Pueblo East Pit M-2000-041 TR-8 Adequacy Review #3

RE: Pueblo East Pit, M-2000-041, Technical Revision No. 8 (TR-8), Adequacy Review No. 3

**East Pit
Reclamation Map
11/10/22
Map By James Higgs**

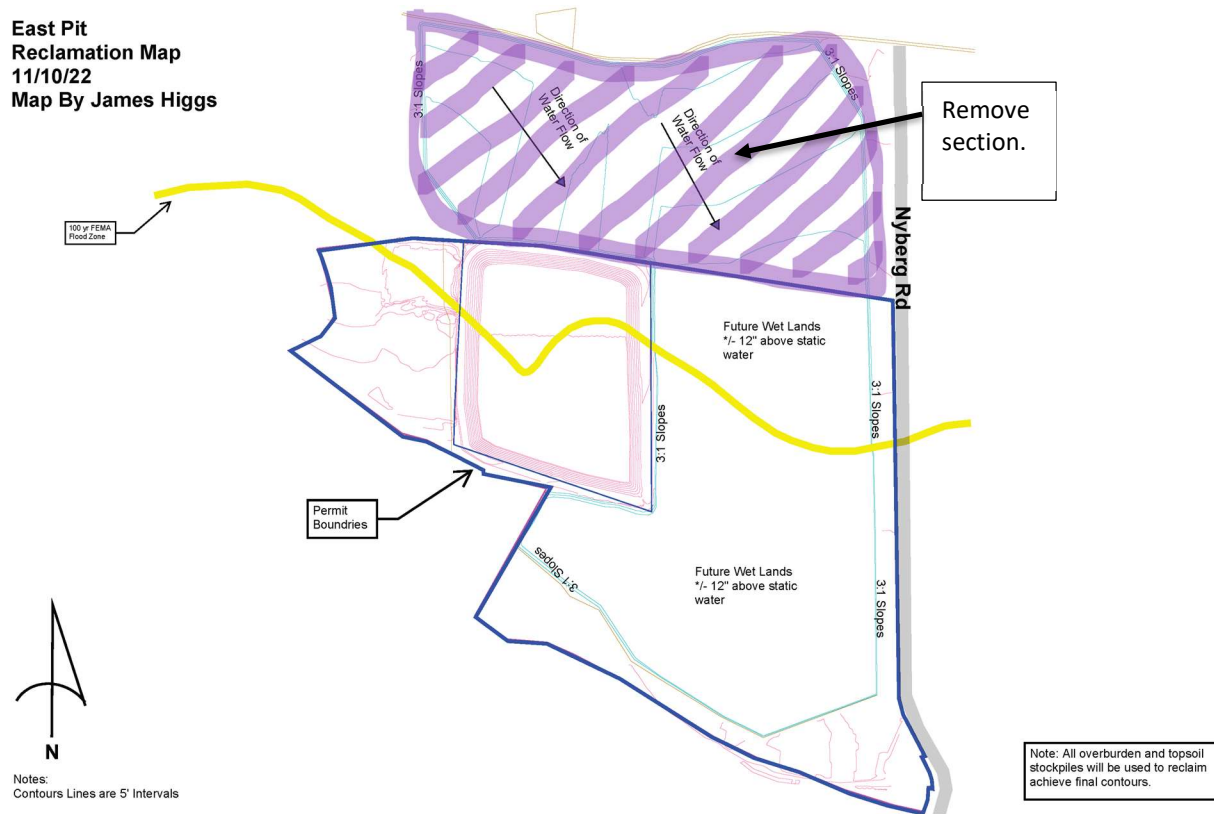
2. There was no updated “East Pit Reclamation Map” submitted in the second adequacy response. The map does not meet the requirements. Please revise the map to address the following issues:

- a. The map must include the preparer’s signature, per Rule 6.2.1(2)(b).
 - b. The date of when the map was prepared/revised needs to be included on the map, per Rule 6.2.1(2)(c).

- c. The area identified needs to correspond to the applicable permit area, per Rule 6.2.1(2)(d). Remove the area to the north of the permit boundary. Revise the map with the northern section removed; please see the below image.

- d. Include an approved scale, per Rule 6.2.1(2)(e).
 - e. Phase 3 has future land-use of "Wet Lands" shown on the map differs from the approved land use of developed water resources that was provided in TR-6. Please clarify.
3. There was no updated "East Pit Future Mining Phase 2" map submitted in the second adequacy response. The map does not meet requirements. Please revise the map addressing the following issues:
- a. The map must include the preparer's signature, per Rule 6.2.1(2)(b).
 - b. The date of when the map was prepared/revised needs to be included on the map, per Rule 6.2.1(c).
 - c. The area identified needs to correspond to the applicable permit area, Rule 6.2.1(2)(d). Remove the area to the north of the permit boundary. Revise the map with the northern section removed; please see the below image.
